**Re: Windsong Subdivision
Map 6, Lot 167
CMA # 1325**

TO: Christian Smith, Beals Associates
FROM: Mark Connors, Planning & Community Development Director
RE: **Windsong Place Subdivision Staff Comments**

We are in receipt of review comments from CMA Engineers, dated April 1, 2024 and we offer the following responses to the noted comments. Each comment is followed by our response in **bold**.

STREET SIGN DETAIL

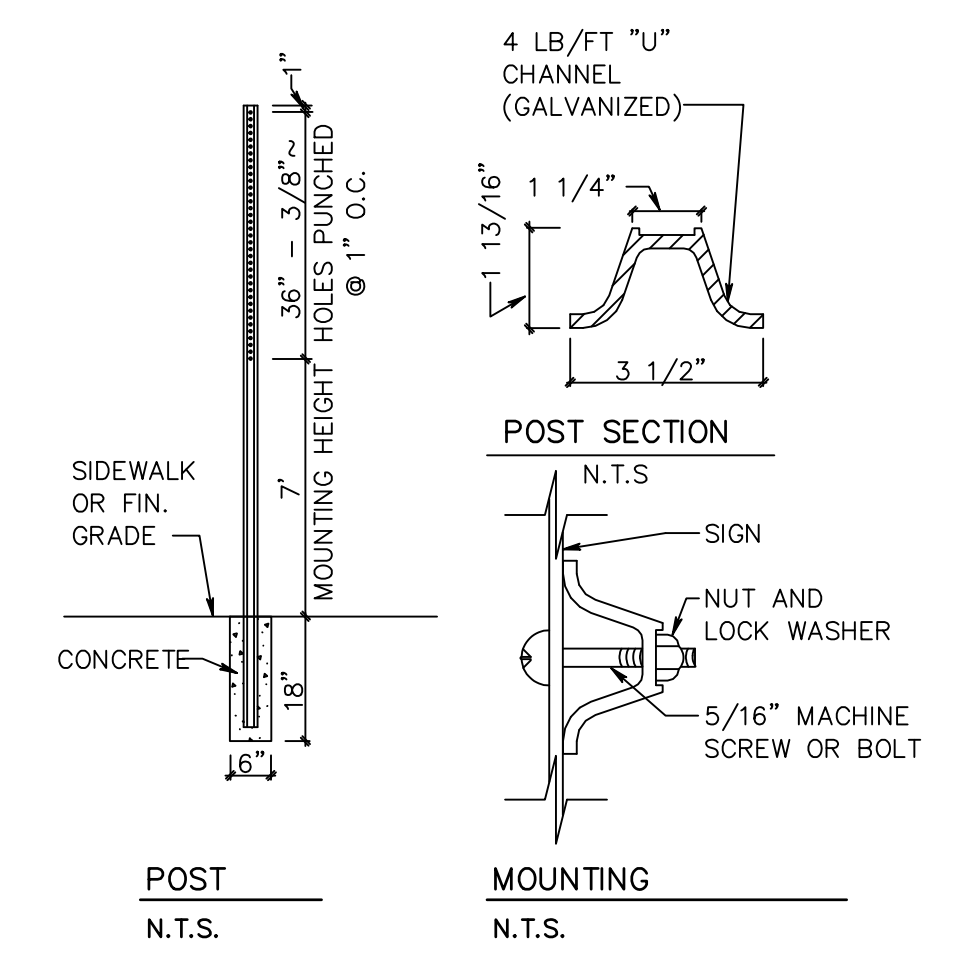
- i) A stop sign and road sign are indicated on the plans but no details are provided. The plans should also show a stop bar.

Response: A sign detail has been added and the addition of a stop bar will be per NHDOT.
